Administrative Action Preliminary Subdivision

Case File / Name: S-5-09 / Unity Subdivision

SUBJECT: S-5-09 / Unity Subdivision

Proposed Subdivision

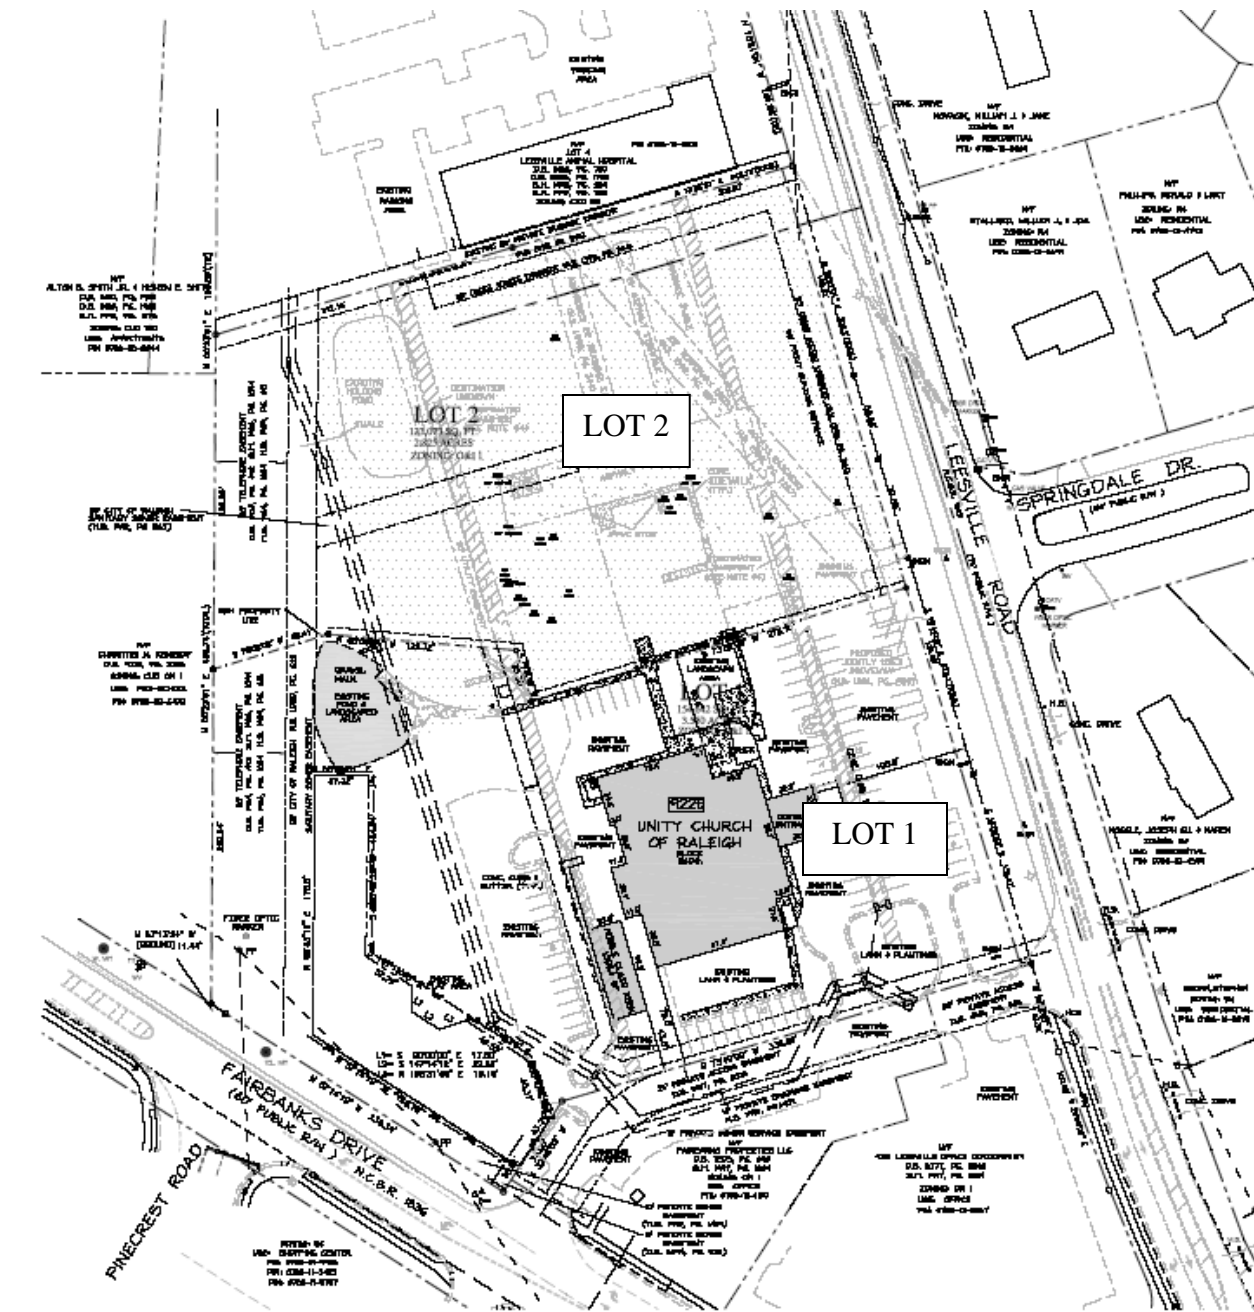
CONDITIONS OF APPROVAL:

- (1) That prior to the issuance of a grading permit, the final tree conservation plan must be approved by the Forestry Specialist in the Inspections Department. The plan must show metes and bounds descriptions of all tree conservation areas, and tree protection fence around all tree conservation areas. Tree protection fence must be located in the field and inspected by the Inspections Department. A copy of the approved plan is to be placed on file in the Planning Department;

- (2) That construction plans for public improvements be approved by the Public Works Department;
- (3) That approved tree conservation areas be shown on all plats for recording with metes and bounds descriptions in compliance with Code section 10-2082.14;

- (4) That all permanently preserved undisturbed open space used to meet the nitrogen reduction requirements of Part 10 Chapter 9 shall be labeled on recording plats. These plats shall include a note stating: Within permanently preserved undisturbed open space areas used for stormwater treatment, there must not be any land disturbing activity, any placement of impervious surfaces, any tree removal, any new development or expansion thereof, or new use, construction, or encroachment;

- (5) That a 25' permanent slope easement and retaining wall easement along Leesville Road be dedicated to the City of Raleigh as shown on the preliminary plan and be shown on all plats for recording. This easement is eligible for reimbursement at Code established rates;

- (6) That the 25' cross access easement (Book of Maps 1998, page 344) along the Leesville Road frontage only, be abandoned and a new proposed 25' cross access easement deed between Lots 1 and 2 and shared driveway access easement deed opposite Springdale Drive be recorded. These easements are to be general access easements between the two lots with
